1. The specifications and drawings for Invitation No. DACW64-02-B-0031, Channel Rectification, Downstream of Cullen to State Highway 288, Sims Bayou, Houston, Texas, advertised 17 July 2002 and for which bids are to be opened on 20 August 2002, are hereby modified as follows:

**QUESTIONS FROM MIDWEST CONSTRUCTION COMPANY, ROBERT VITEK AND ANSWERS BY THE GALVESTON DISTRICT DESIGN TEAM**

File 7586S  
**SIMS BAYOU, HOUSTON, TEXAS,  
 DOWNSTREAM OF CULLEN TO  
 STATE HIGHWAY-288,  
 CHANNEL RECTIFICATION**

**INVITATION NO. DACW64-02-B-0031**

"THIS DRAWING ACCOMPANIES AMENDMENT NO. 0001  
TO INVITATION NO. DACW64-00-B-0031."  
ATTACHMENT NO. 9

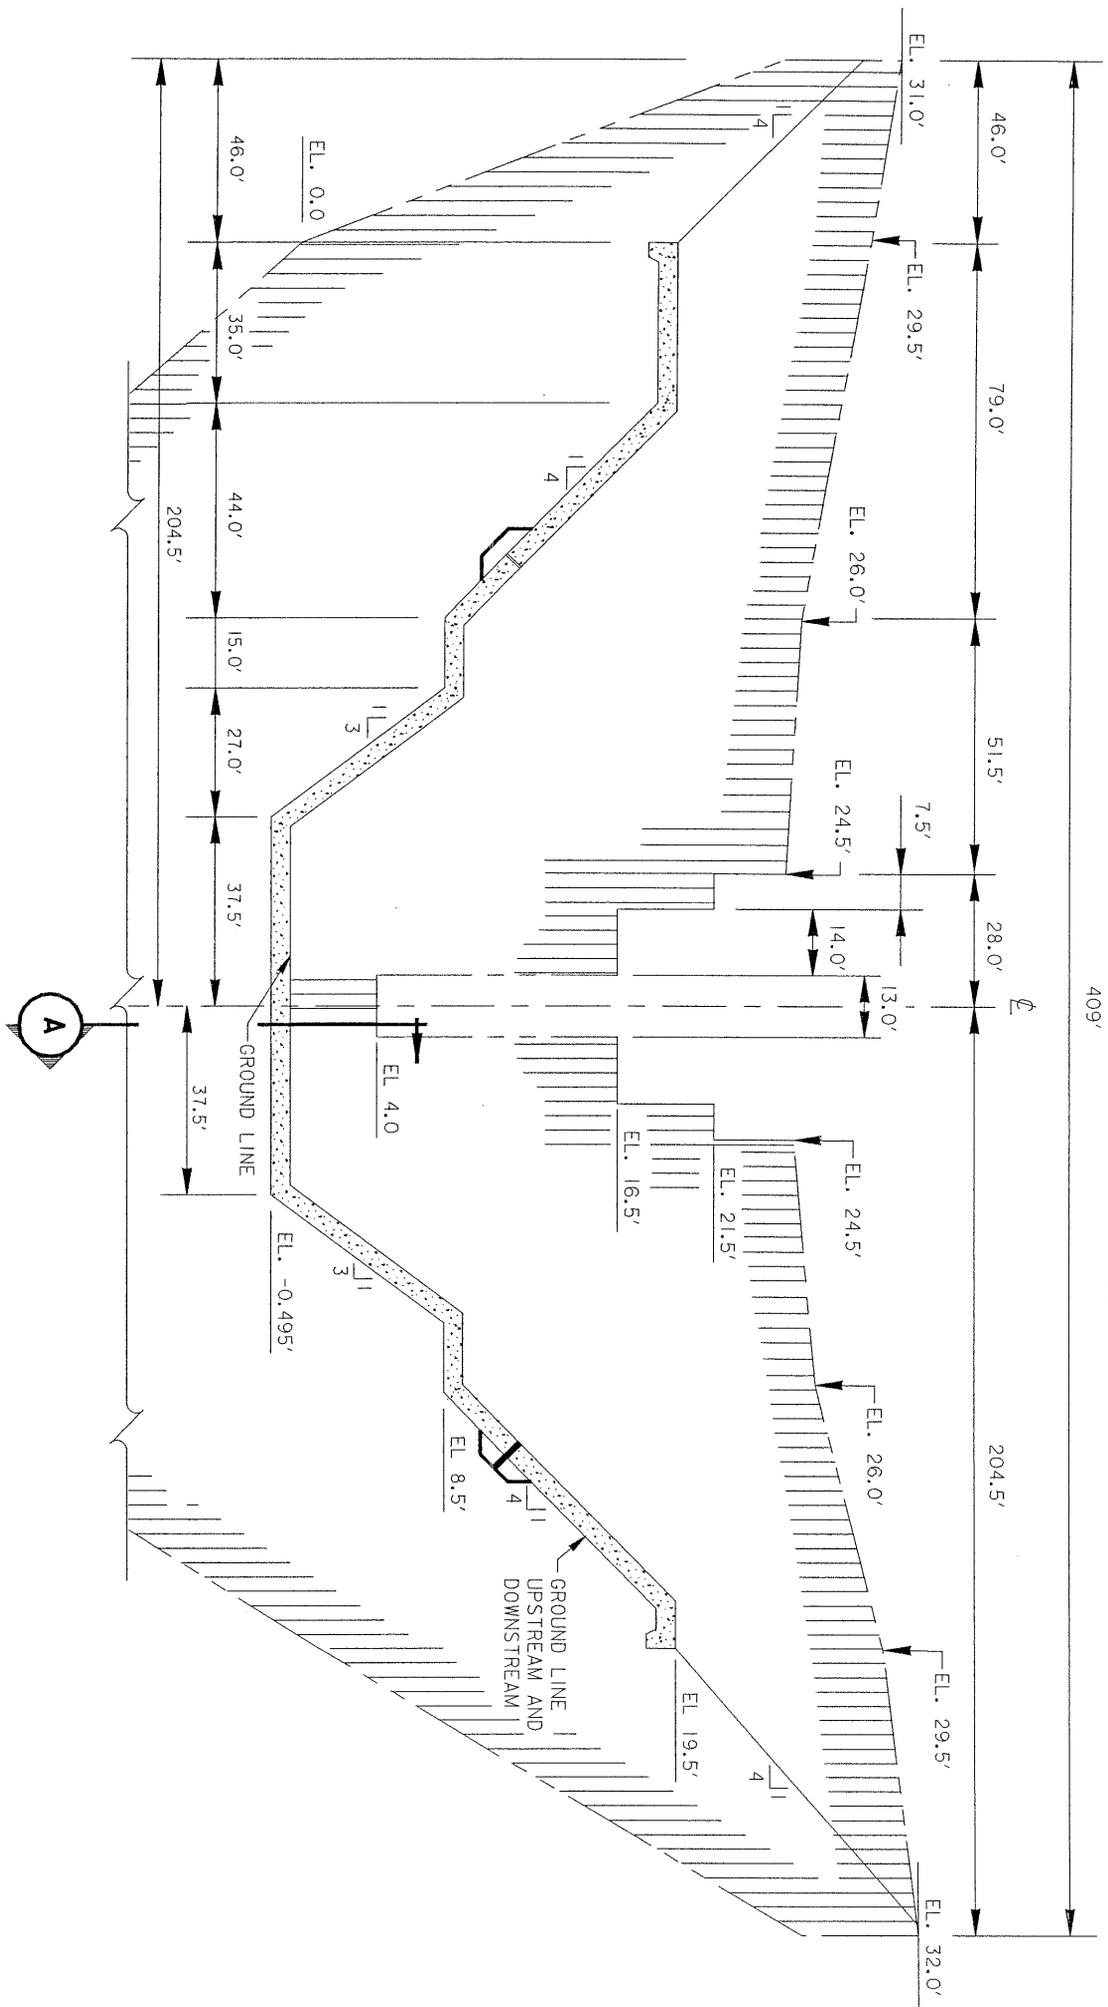
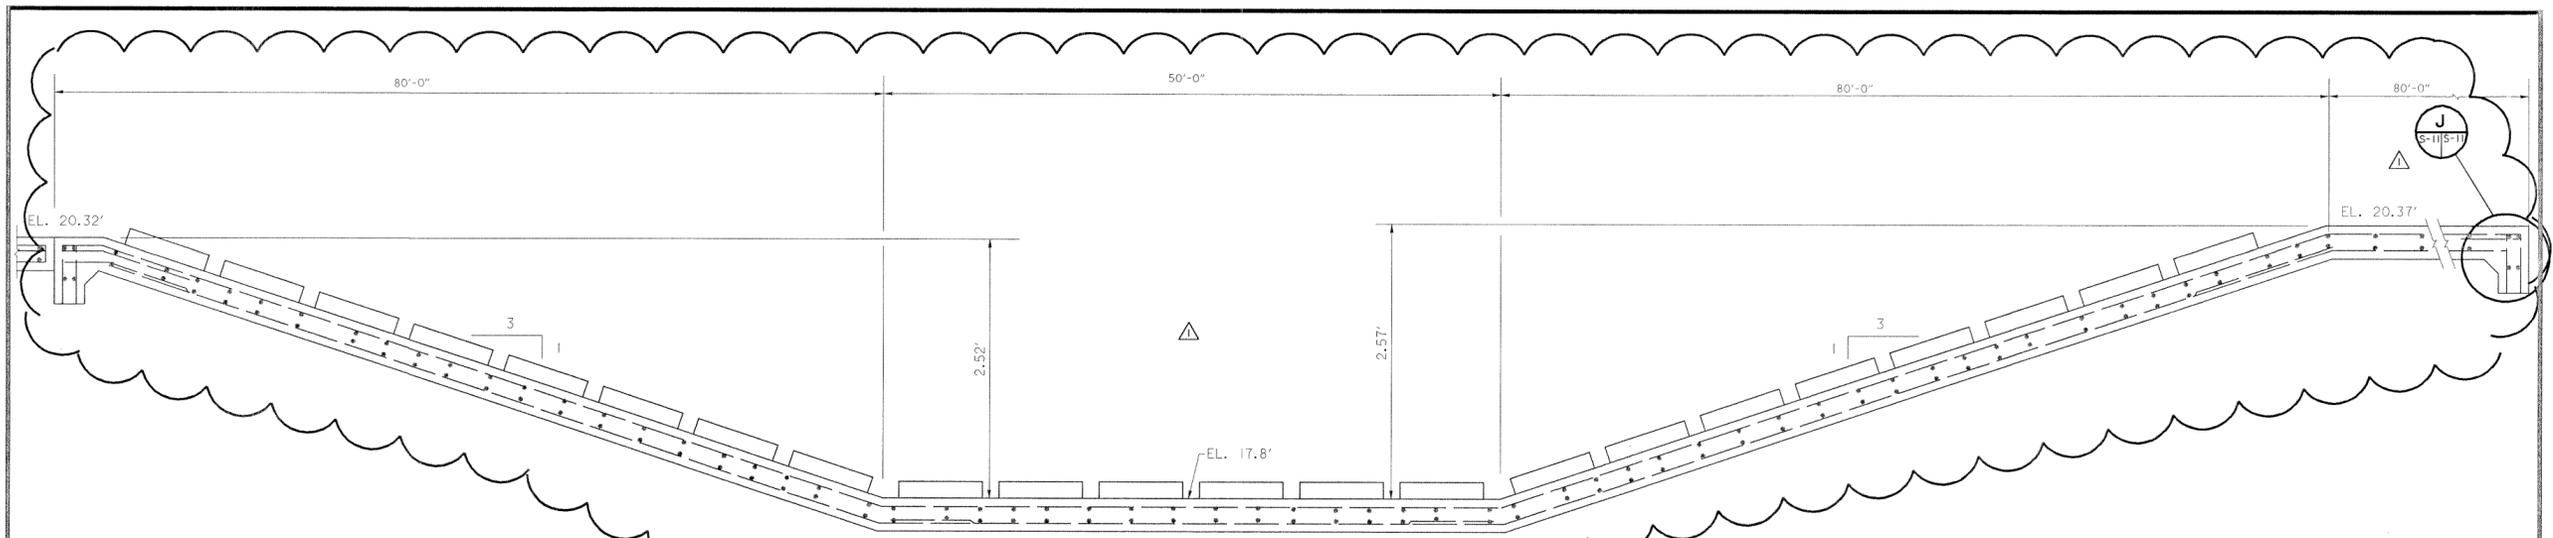
(58) Drawing No. OS-8 - The enclosed ATTACHMENT NO. 9 shall replace SECTION STA. 336+50 shown.

**LOW WATER CROSSING**  
**BOX SECTION**  
 NOT TO SCALE

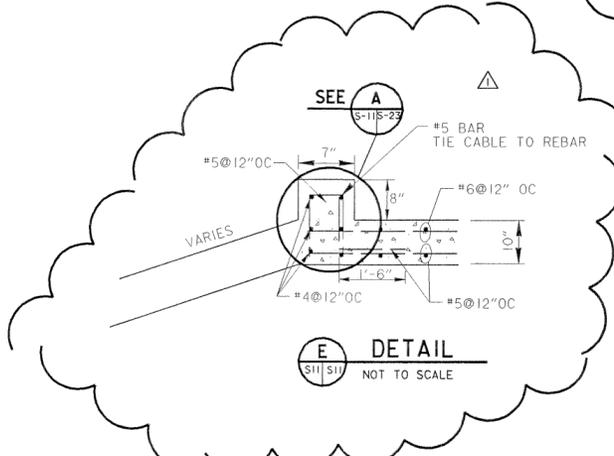
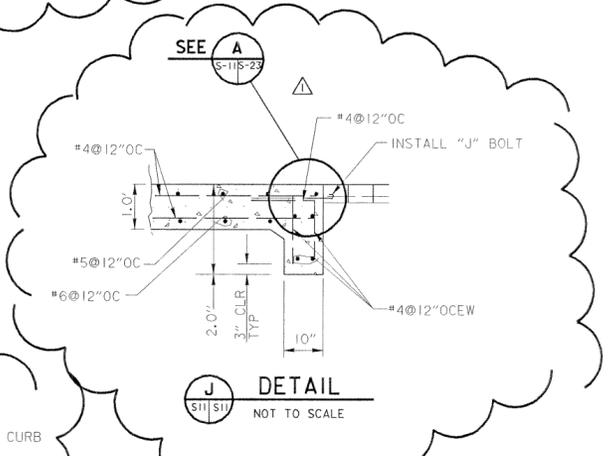
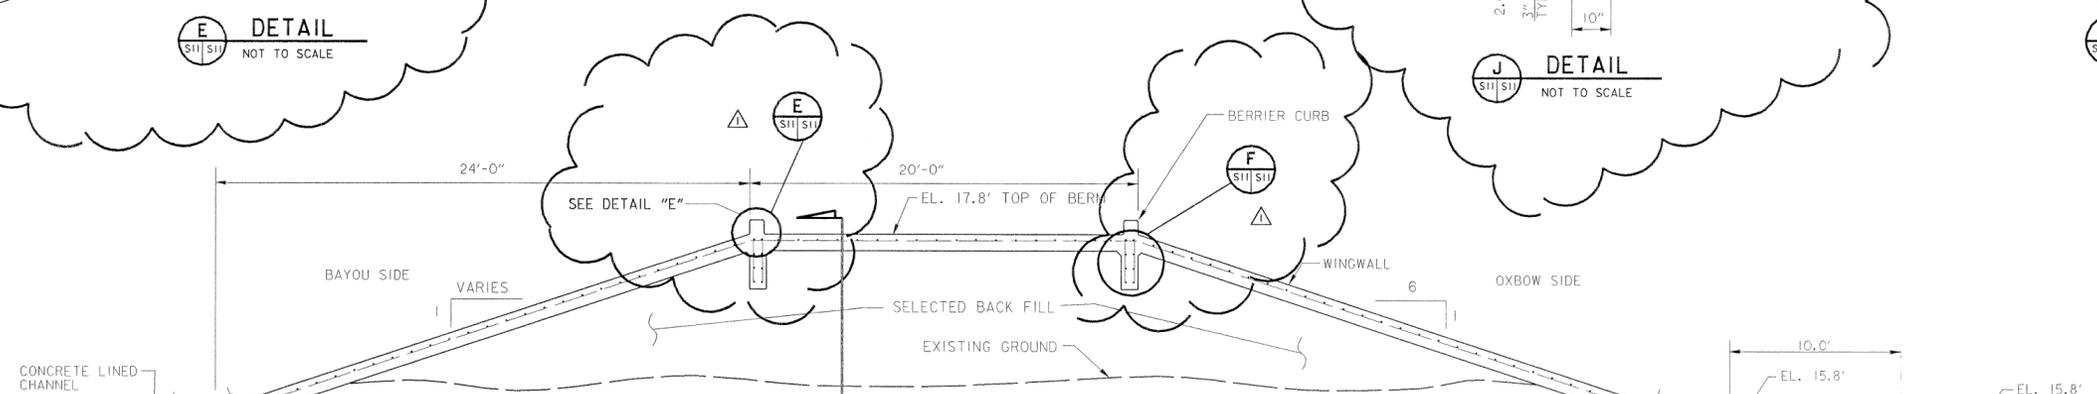
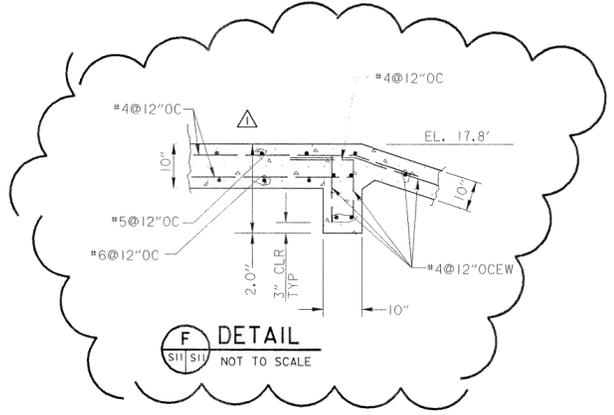
QUESTION 4 - I cannot find any reference to layout or depth for the 3-5'x5'x67' box culvert, Sta. 616+60 Rt, as shown in the New Storm Drain Summary, plan sheet C-31. I did find a reference to a box culvert in Section D, plan sheet S-11, but it does not make any sense, there is not a cut section D on that sheet in the plan or profile.?

(36) Drawing No. S-11 - The enclosed new DRAWING NO. S-11 shall supersede that issued with this Invitation.

ANSWER 4 - The 5'x5'x67' box culvert that was supposed to be constructed at Sta. 616+60 is being deleted by this Amendment No. 0001. In its place we are constructing a low water crossing. Details for the low water crossing are shown on the new Drawing No. S-11 that is enclosed with this Amendment No. 0001.
